Applied Science Associates, Inc. Report dated March 16, 2009,  
"Review of Thermal Discharge Issues to the Hudson River in NRC Draft  
SEIS for Indian Point 2 and 3"

ENERGY NUCLEAR OPERATIONS, INC  
INDIAN POINT NUCLEAR GENERATING UNIT NOS. 2 and 3  
DOCKETS 50-247 and 50-286

**Review of Thermal Discharge Issues to the Hudson  
River in NRC Draft SEIS for Indian Point 2 and 3**

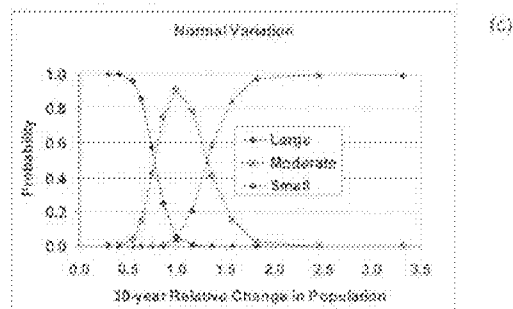
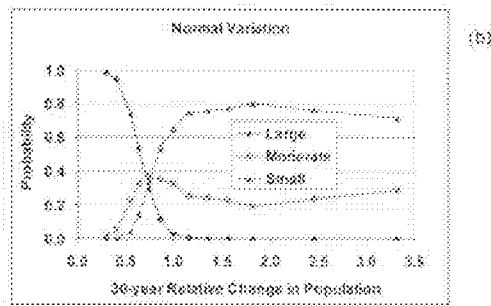
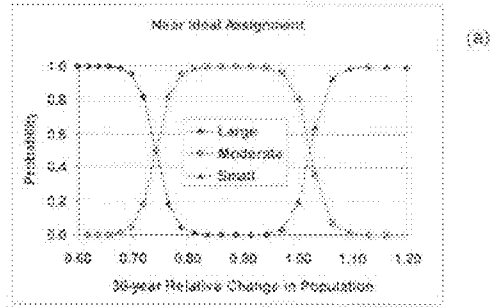
Classification probabilities for an "ideal" procedure are illustrated in figure 1a, and the probabilities calculated for NRC's classification procedure are illustrated in figure 1b. In Figure 1a, the ranges of population change over which more than one classification is possible are small ( $-0.65$  to  $-0.85$  and  $-0.95$  to  $-1.1$ ), and there are no rates of population change for which more than two classifications are possible. As shown in Figure 1b, probabilities of misclassification are high using NRC's procedure. There is a 20%-40% chance that a trend will be classified as Moderate for population

To illustrate the potential for improvement of the classification process, a simpler set of rules was applied to the simulated data (Appendix A). This scheme produced Large, Moderate, and Small classifications that were much more distinct than those produced by NRC's rules (Figure 1c). Separation of the Large and Small categories was nearly complete, and a Moderate category centered on relative change  $\approx 1$ , where the probability of Large and Small was very low. The zones of overlap of two categories, either Large with Moderate or Moderate with Small, are much smaller than with the classification rules used by NRC. This alternate classification is still conservative, because population that are growing, but at a relatively low rate (up to about a 120% increase over 30 years) have a higher probability of being incorrectly classified as Moderate than of being correctly classified as Small.

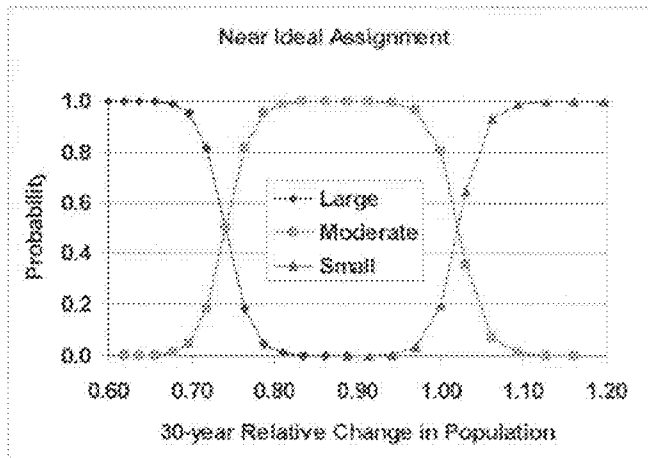
Ideally, a classification process would be able to delineate distinct classes based on true values of population parameters. An ideal classification process would have large ranges of population change where only one of the classes is possible, and small ranges where probabilities for two classes overlap (Figure B-2). The nearly ideal hypothetical classification depicted has uncertainty in classification only when 30-year relative change in the population is near 0.75 or 1.05. In each case the uncertainty is only between two of the three classes.

Figure B-3. Classification under NRC decision rules of simulated population abundance data with normal variation around the expected value,  $\delta = 0.25$ . Probabilities for the three classifications always sum to unity.

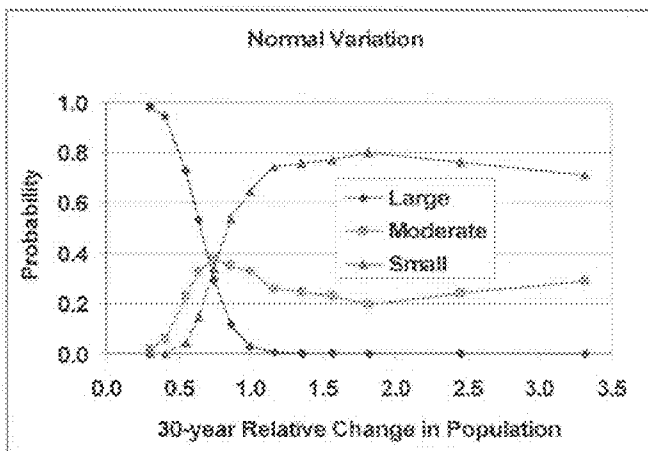
The NRC process, for a population with normal variation in annual abundance and  $\delta \approx 0.25$ , departs substantially from the ideal (Figure B-3). The delineation between the Large and Small categories of potential impact was relatively distinct, with overlap of the categories occurring only in the range of 0.5 to 1.0 relative change in population size. However, the probability that a population could be classified as Moderate potential impact was between 0.2 and 0.4 for population change ranging from 0.5 to 3.3, i.e. a population that had declined to 50% of its original abundance and a population that had grown to more than 3 times its original abundance have essentially the same probability of being classified as Moderate potential impact. The probability that a population would be classified as having a Large potential impact was also non-trivial for populations that had declined relatively little: 0.32 for a trend resulting in 0.7 of initial abundance, 0.12 for a trend resulting in 0.9 of initial abundance, and 0.03 for a population with unchanged abundance. The 0.6 to 0.9 range in population change is a zone in which discrimination is highly uncertain as the probabilities of the Large potential impact category range from 0.53 to 0.11; probabilities of the Moderate category range from 0.33 to 0.37; and probabilities of the Small category range from 0.14 to 0.65.

Figure B-4 Classification under NRC decision rules of simulated population abundance data with log-normal variation around the expected value,  $\delta = 0.25$ . Probabilities for the three classifications always sum to unity.

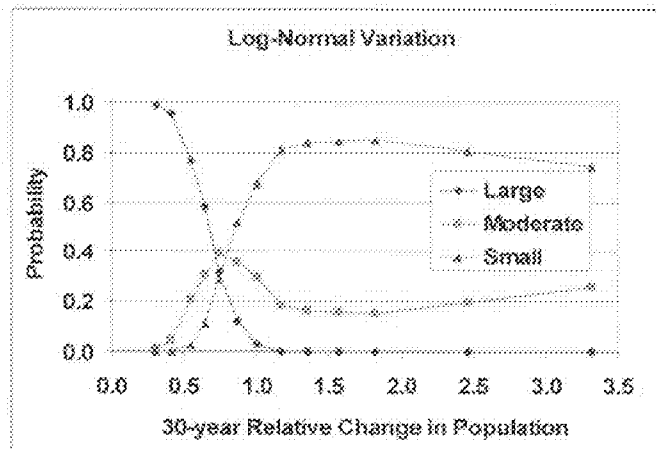
If population variation is lognormal rather than normal, the operating characteristics of the NRC classification are essentially the same (Figure B-4), although

between relative population change from about 1.2 to 2.5 the probability of a population being classified as Moderate impact declines slightly below 0.2.

Figure B-5 Classification under NRC decision rules of simulated population abundance data with normal variation around the expected value,  $\delta = 0.25$ , after applying a 3-year moving average. Probabilities for the three classifications always sum to unity.

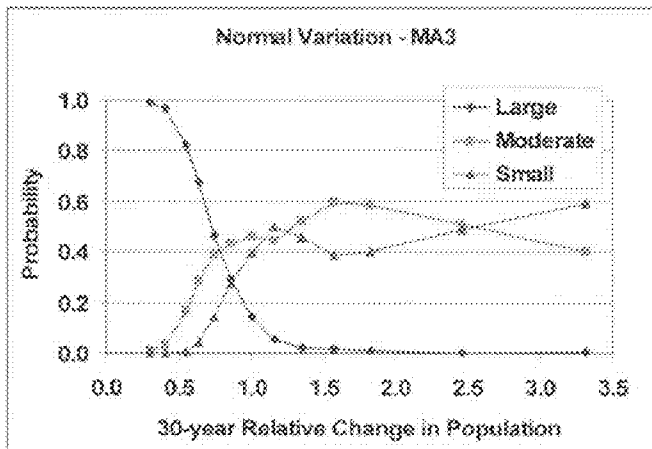
Smoothing the data series with a 3-year moving average prior to analysis resulted in the classification process being even less able to distinguish Moderate from Small impact. Populations that increased in abundance (population change greater than 1.0) had nearly equal likelihood of being classified Small or Moderate (Figure B-5).

Figure B-6 Classification under NRC decision rules of simulated population abundance data with normal variation around the expected value,  $\delta = 0.10$ . Probabilities for the three classifications always sum to unity.

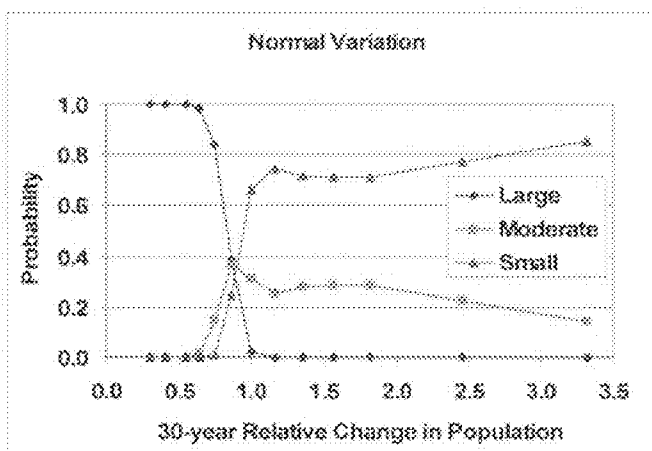
Simulation results for less variable population abundances,  $\delta = 0.10$ , were also qualitatively similar although the probability of a Moderate classification began to drop below 0.2 at population changes above 2.5 (Figure B-6).

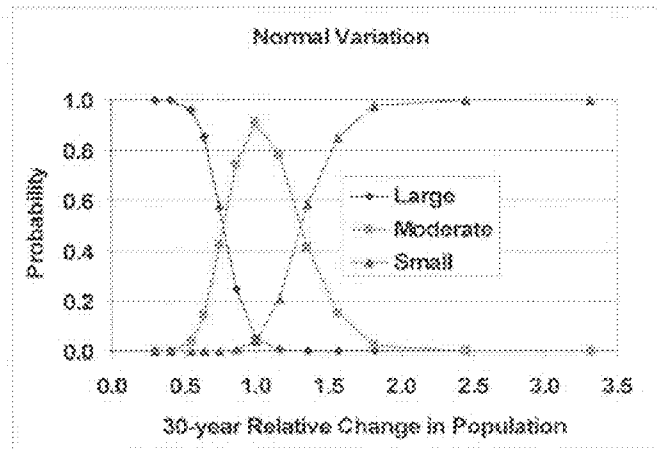
This rule resulted in nearly complete separation of the Large and Small categories, and a Moderate category centered on relative change = 1, where the probability of Large and Small was very low (Figure B-7). The zones of overlap of two categories, either Large with Moderate or Moderate with Small, are much smaller than with the classification rules used by NRC. This classification scheme may or may not be preferable for NRC's purpose, but it illustrates that different sets of rules can produce very different classifications for the same data, and that no classification scheme should be used without first testing its performance on data with known characteristics.
